SERVICE BULLETIN MAINTENANCE OF WAY EQUIPMENT

BULLETIN NO: 11-010

TITLE: Spring Cell Assembly Replacement

PRODUCT SERIES / MODEL: HR4000 Series V1 HY-RAIL® Guide Wheel Units

FIGURE 1
REMOVING SPRING CELLS FROM GUIDE WHEEL UNIT

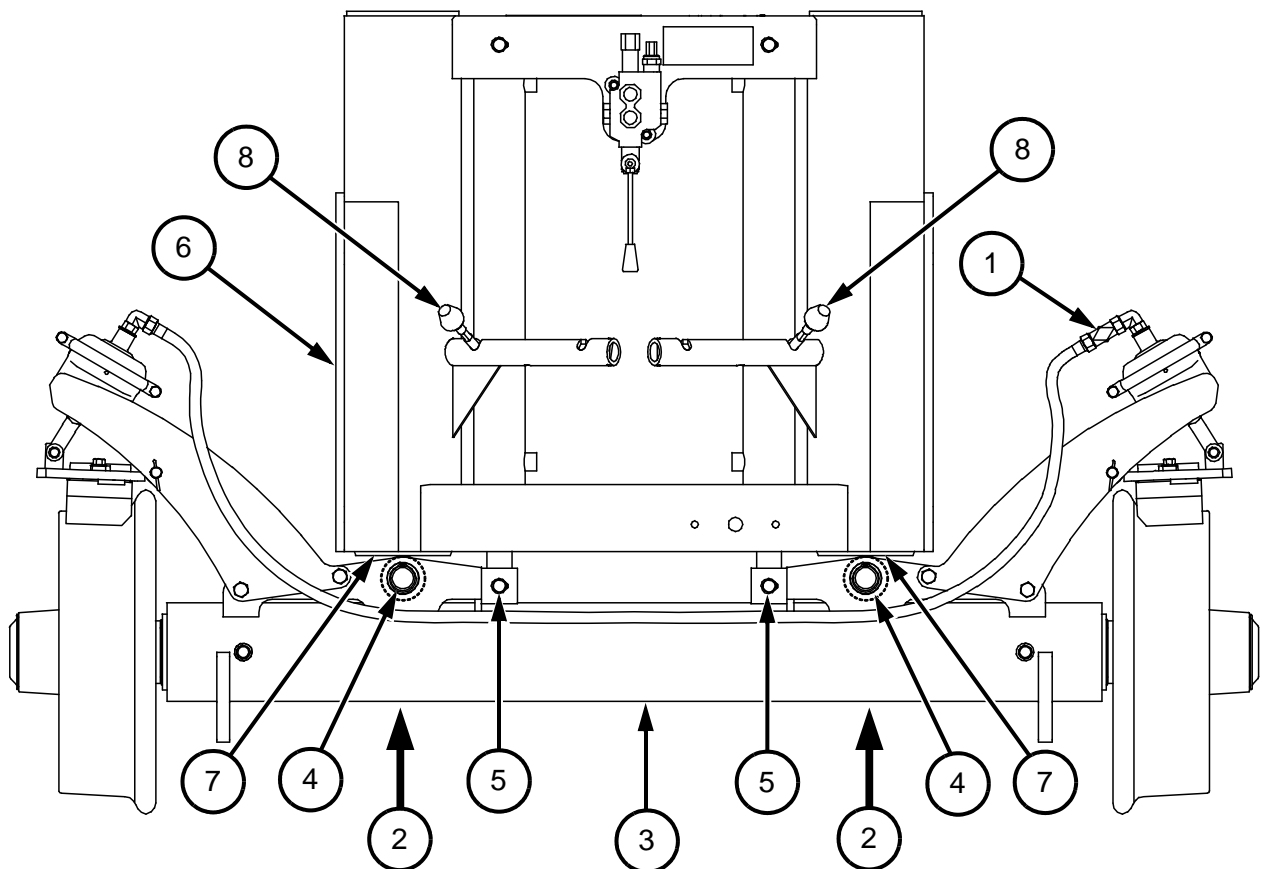
SUMMARY: It has come to the attention of HarSCO Rail that the end cap on the spring cell base may not have been properly welded. If the weld that secures the end cap to the spring cell base breaks, the axle assembly will separate from the spring cell assembly. If this happens while the guide wheel unit is raised in the highway position, the end of the axle assembly may fall to the ground. If this happens while the guide wheel unit is lowered and the vehicle is on rail, the vehicle most likely will derail. To correct this problem, HarSCO Rail has identifying the HR4000 Series V1 HY-RAIL® guide wheel units that were shipped from the factory with incorrect welds on the spring cell base. The affected vehicles must be removed from service immediately and taken to the nearest approved HY-RAIL® guide wheel equipment repair facility. If it is desirable to keep the vehicle in service, without using the vehicle on rail, chains, straps, etc. must be put in place to secure the guide wheel unit axle to the upper structure. HarSCO Rail is providing Spring Cell Service Group #5012396 which will include fully assembled left and right spring cell assemblies.

OPERATIONAL IMPACT: If the weld that secures the end cap to the spring cell base breaks, the axle assembly will separate from the spring cell assembly. If this happens while the guide wheel unit is raised in the highway position, the end of the axle assembly may fall to the ground. If this happens while the guide wheel unit is lowered and the vehicle is on rail, the vehicle most likely will derail.

3. Remove the vehicle air brake hose from Tee (1) in the air brake line. Cap / plug the air brake hose and Tee connections.
4. Although it is possible to use one floor jack under the center of the guide wheel unit axle assembly, it is recommended to use two floor jacks, each one located under the axle assembly, centered below the spring cells. See point (2) on Figure 1.

5. Jack the axle assembly (3) up slightly to remove the pressure from the spring cell pins (4) and hydraulic cylinder pins (5).
6. Remove the snap rings from one end of the spring cell pins (4) and hydraulic cylinder pins (5). Remove the four pins and set aside. The pins and snap rings will be reused.

7. Using the jacks, slowly lower both ends of the axle assembly. Remove the axle assembly from under the guide wheel unit.

8. Using a jack that is rated to lift the weight of the front of the vehicle, jack the front of the vehicle up. The spring cell assembly is approximately 32-1/2 inches (826 mm) long. The vehicle must be jacked up enough to allow space for the spring cell assembly to be removed plus the height of the jack that will be used to remove and reinstall the spring cell assembly. As a guide, the distance from the bottom of the upper structure (6) to the floor should be at least the length of the spring cell assembly plus the height of the floor jack.
Important: Place jack stands or blocks under the vehicle frame to support the vehicle while removing / installing the spring cell assemblies.

9. Place a floor jack under one spring cell assembly (7). Jack the spring cell assembly (7) up slightly to remove the pressure from the lock pin (8). Rotate the lock pin handle (8) up, pull it out and rotate it down to secure it in the disengaged position.

10. Using the jack, slowly lower the spring cell assembly (7) out of the upper structure (6).
11. Repeat Steps 9 and 10 to remove the other spring cell assembly (7) from the upper structure (6).

12. Do not disassemble the spring cell assemblies. Set both spring cell assemblies aside, they will need to be returned to Harsco Rail. Contact Harsco Rail, HY-RAIL® Parts Sales for instructions on returning the spring cell assemblies to the factory.

**FIGURE 2
INSTALLING NEW SPRING CELLS IN GUIDE WHEEL UNIT**

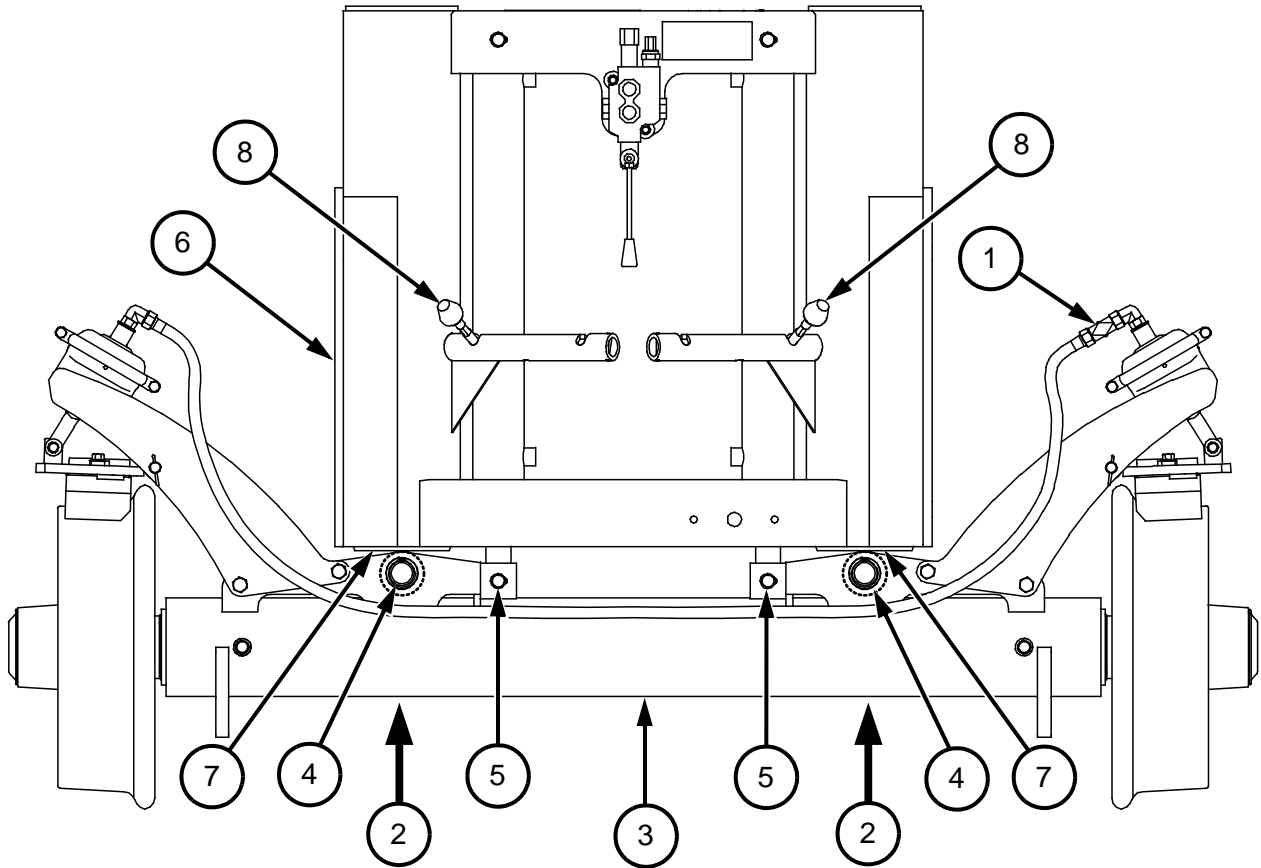
Note: The left and right spring cell assemblies are different. Make sure to install the left spring cell assembly #5012393 on the left side of the vehicle (passenger side) and the right spring cell assembly #5012395 on the right side of the vehicle (driver's side).

1. Place the spring cell assembly (7) on the floor jack. Jack the spring cell assembly fully up into the upper structure (6) until lock pin (8) can be inserted in the lock pin hole in the spring cell assembly. Rotate the lock pin handle (8) up, push it in to engage the lock pin and then rotate it down to secure it in the engaged position.

2. Lower the floor jack. Repeat Step 1 to install the other spring cell assembly in the upper structure.
3. Remove the jack stands or blocks from under the vehicle frame. Lower the front of the vehicle down to the floor. Move the jack away from the vehicle.

4. Position the axle assembly (3) under the spring cell assemblies (7). Using two floor jacks, jack the axle assembly (3) up until the spring cell pins (4) and hydraulic cylinder pins (5) can be inserted. Secure the spring cell pins (4) and hydraulic cylinder pins (5) with the snap rings. Remove the floor jacks from under the axle assembly.

5. Reconnect the vehicle air brake hose to Tee (1) in the air brake line.
6. Start the vehicle engine. Remove the chocks from the vehicle wheels on the rear axle.
